Rampion 2 Wind Farm

Outline Construction Traffic Management Plan (tracked)

Date: August 2024
Revision G

Document Reference: 7.6
Pursuant to: APFP Regulation 5 (2) (q)
Ecodoc number: 004866600-07

Figure 7.6.4d Temporary construction and operational accesses

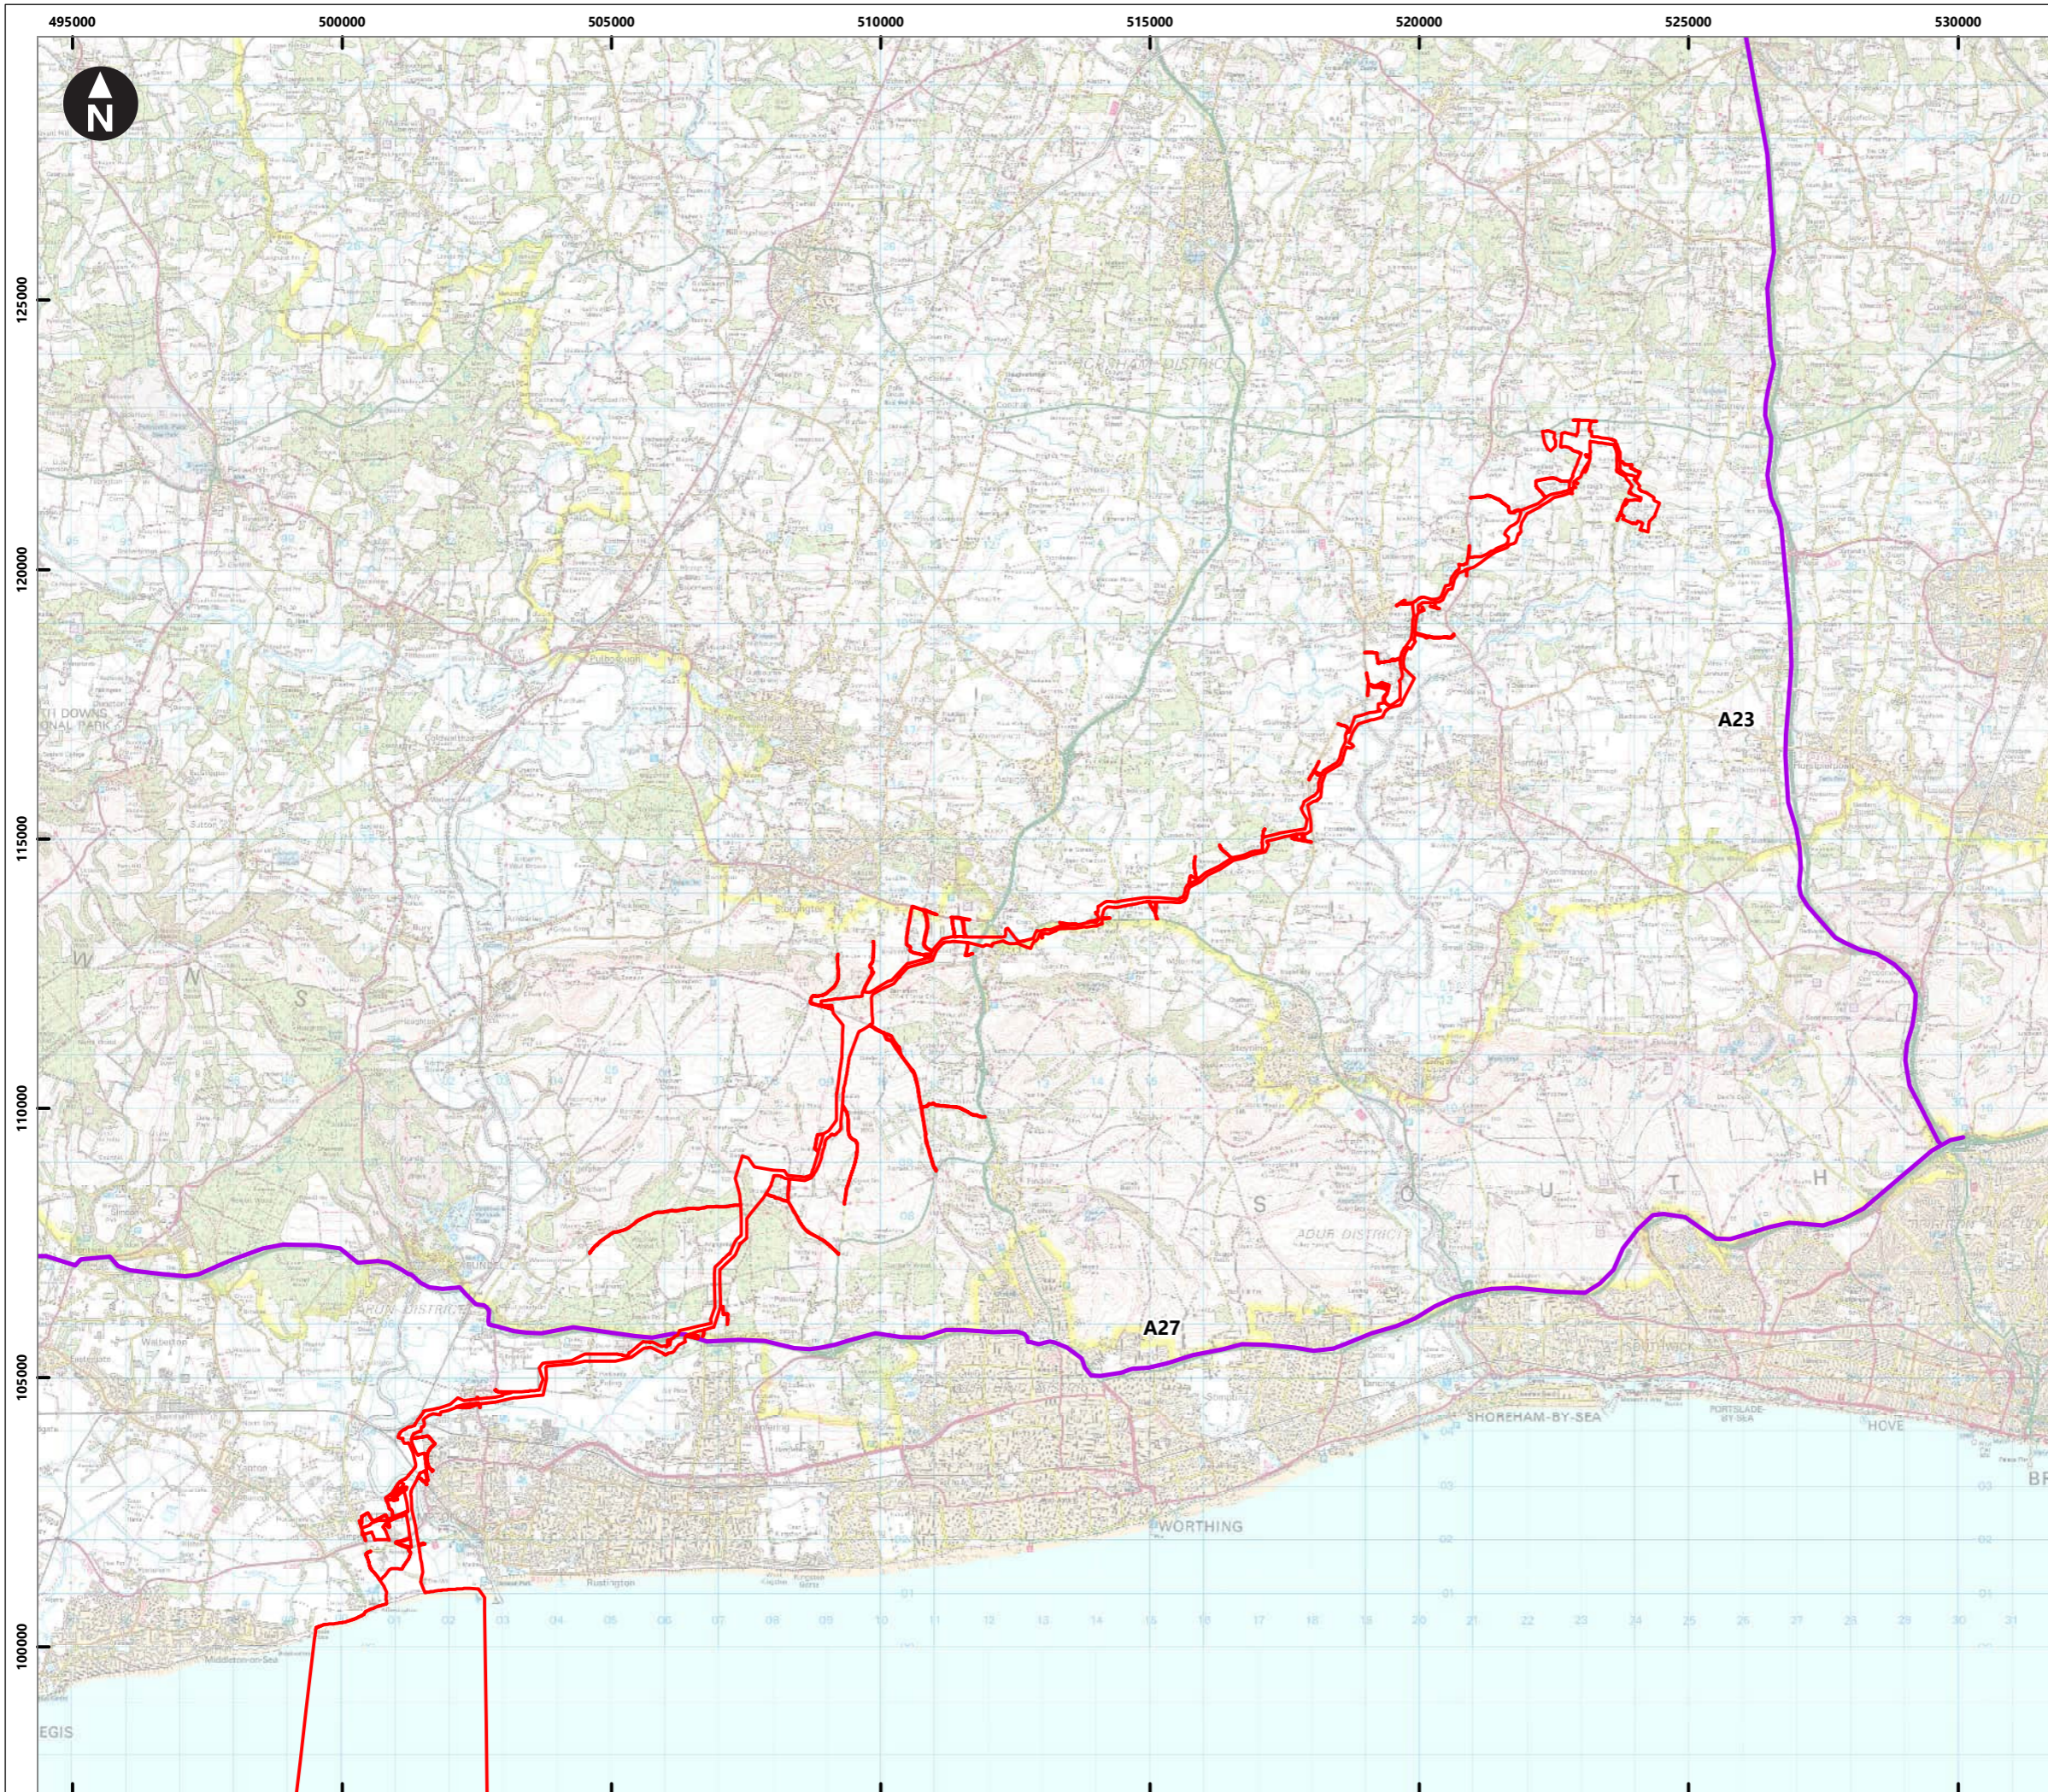
WSSC Local Impact Report Comment	Recommended Action	Applicant's Response to WSSC Local Impact Report	Applicant's amendment to the Outline CTMP
<p>Appendix B, Figure 7.6.4d Temporary Construction and Operational Accesses</p> <p>The access tracks leading from the B2135 at A56 and A57 (construction and operational) are narrow. This could cause vehicles to queue back onto the highway.</p>	<p>Passing places should be provided on the access tracks to enable two vehicles to pass. Alternately traffic management measures may be required to avoid conflicting movements.</p>	<p>[PEPD-009] the Applicant will include additional wording to reflect West Sussex County Council's comments within Appendix B of the Outline Construction Traffic Management Plan [REP1-010]. This will be included in an update to the Outline Construction Traffic Management Plan [REP1-010] at Deadline 3.</p>	<p>Additional wording added to Appendix A under Access A-56 and A-57.</p>

WSCC Local Impact Report Comment	Recommended Action	Applicant's Response to WSCC Local Impact Report	Applicant's amendment to the Outline CTMP
<p>Appendix B, Figure 7.6.4d Temporary Construction and Operational Accesses</p> <p>A67 (construction and operational) and A68 (construction) are both existing. There are no concerns with the accesses themselves, but measures will be required along Wineham Lane to mitigate the additional construction traffic. This may also require measures at the A272 Wineham Lane junction.</p>	<p>Measures will be required to control and avoid conflicting vehicle movements along Wineham Lane Additional measures should be included to assist exiting HGVs both at the Wineham Lane accesses but also at the A272 Wineham Lane junction. Signage may also be required to alert drivers on the A272 to the presence of exiting/turning HGVs. HGV movements should be timed to avoid the network peak hours where possible.</p>	<p>At peak construction the Proposed will generate approximately 40 heavy goods vehicle (HGV) movements per day, which is the equivalent of 3-4 vehicles per hour or one every 15-20 minutes. Based on these peak construction traffic estimates, it is unlikely that the majority of existing traffic will meet an HGV traveling between the A272 and construction site. It is also noted that Wineham Lane has a suitable carriageway width to allow general traffic to pass HGVs on the rare occurrences this occurs. Notwithstanding the above, the Applicant will review this request and provide an update to the Outline Construction Traffic Management Plan [REP1-010] at Deadline 3 where appropriate.</p>	<p>Additional wording added to Appendix A under Access A-67 and A-68 to reference the requirement for a temporary 40mph speed limit on Wineham Lane, which is also included in Section 8.2.</p>

Figure 7.6.6b Local Access Routes

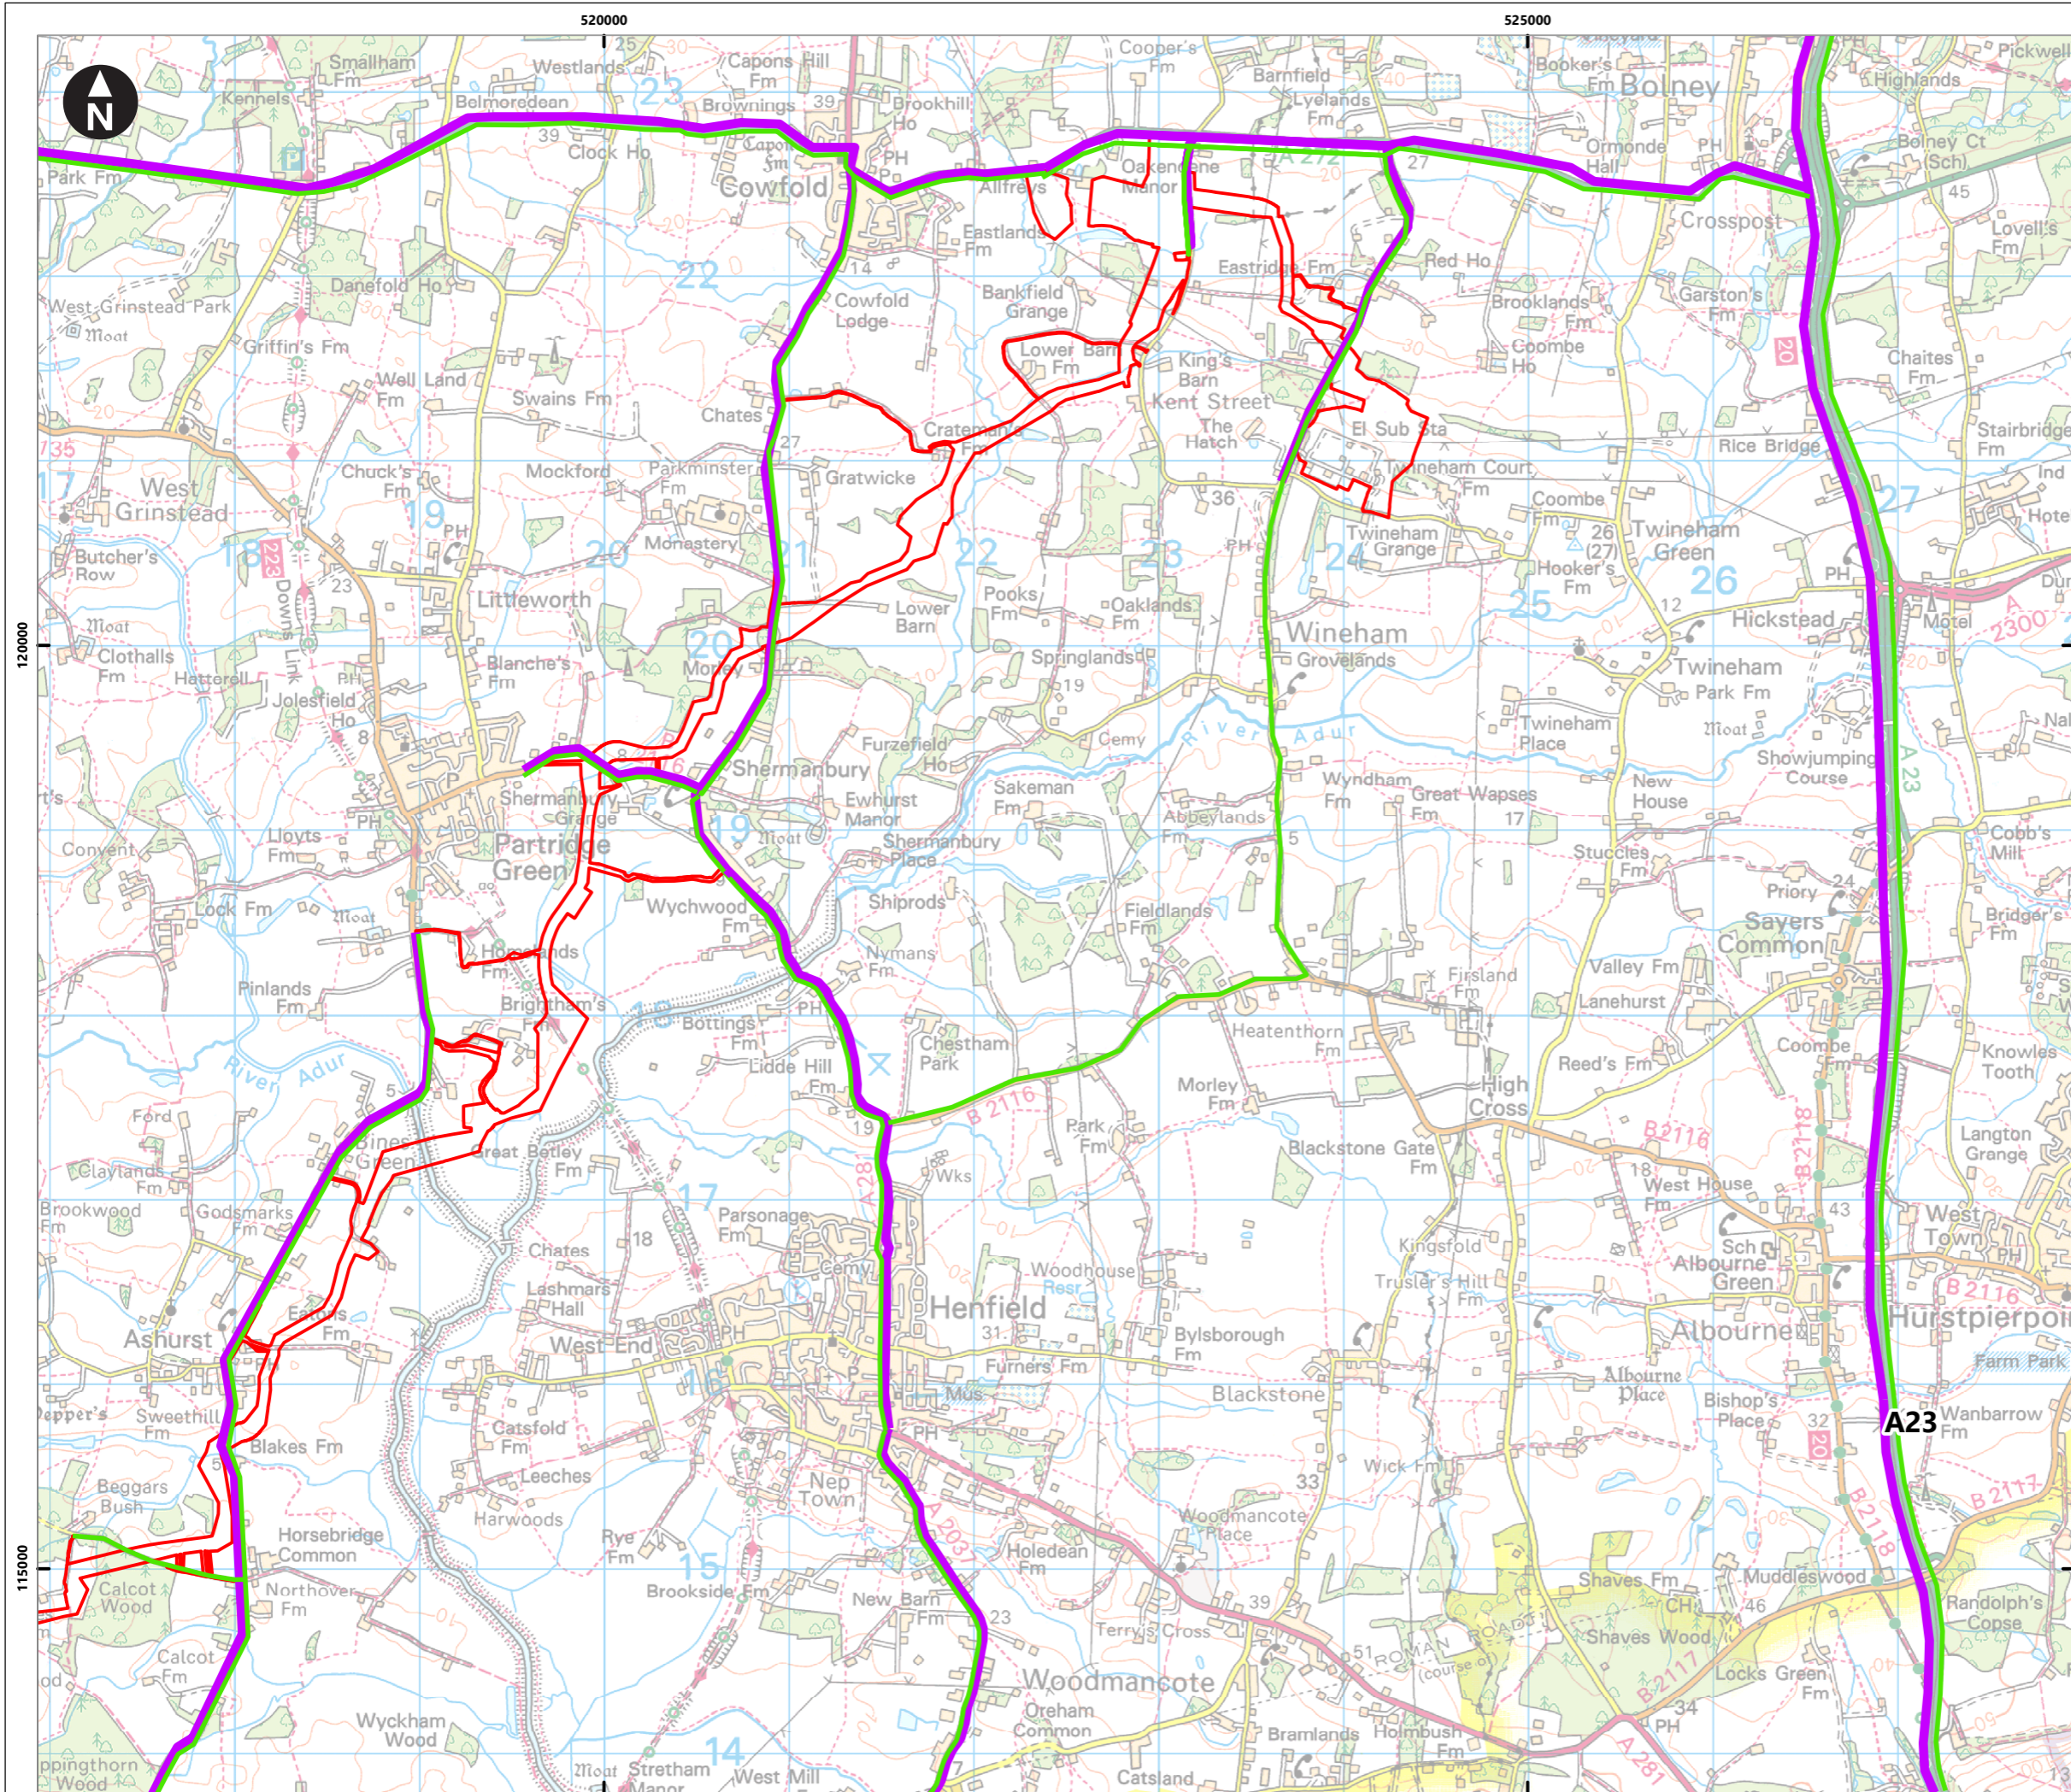
Stakeholder comment	Applicant's response	Applicant's amendment to the Outline CTMP
Horsham District Council [REP4-084]		
<p>Figure 7.6.6b Local Access Routes (Outline Construction Traffic Management) shows that Storrington AQMA is a potential route for LGVs. Horsham District Council rejects routing of vehicles through Storrington. The Storrington AQMA is the only monitoring site in the district that is still recording concentrations within 10% of the annual mean objective. There are other viable alternative routes for LGVs to access the Washington compound and there should be no need for LGVs to go through the AQMA.</p> <p>Although the HGV are not proposed to go through the AQMA, there is a proposed HGV route on the A283 that leads to Storrington. More information regarding the number of HGV on this proposed route is required and also on how HGV use will monitor and controlled by the Project Team.</p>	<p>Figure 7.6.6b of the Outline Construction Traffic Management Plan [REP4-045] shows potential light goods vehicle (LGV) routes to site based upon journey to work information derived upon Census 2011 data. Given that the route through Storrington uses the A283 this is considered the most appropriate route for construction workers traveling to site from areas to the west. Further to this, Table 2-15 within Chapter 32: ES Addendum, Volume 2 of the Environmental Statement (ES) [REP1-006] updated at Deadline 5 shows an estimated peak week construction traffic flow of approximately 150 vehicles day at Receptor O (A283 Storrington Road, Northeast of Sullington Lane), equivalent to less than a 1.0% increase in baseline traffic flows. Noting this estimate includes LGVs associated with access A-33, the number of construction traffic vehicles passing through Storrington will not be significant.</p> <p>In relation to HGVs, the A283 west of access A-33 is not a permitted HGV route. This is shown on Figure 7.6.6b of the Outline Construction Traffic Management Plan [REP4-045]. Further to this, Appendix A of the Outline Construction Traffic Management Plan [REP4-045] defines that</p>	Not applicable.
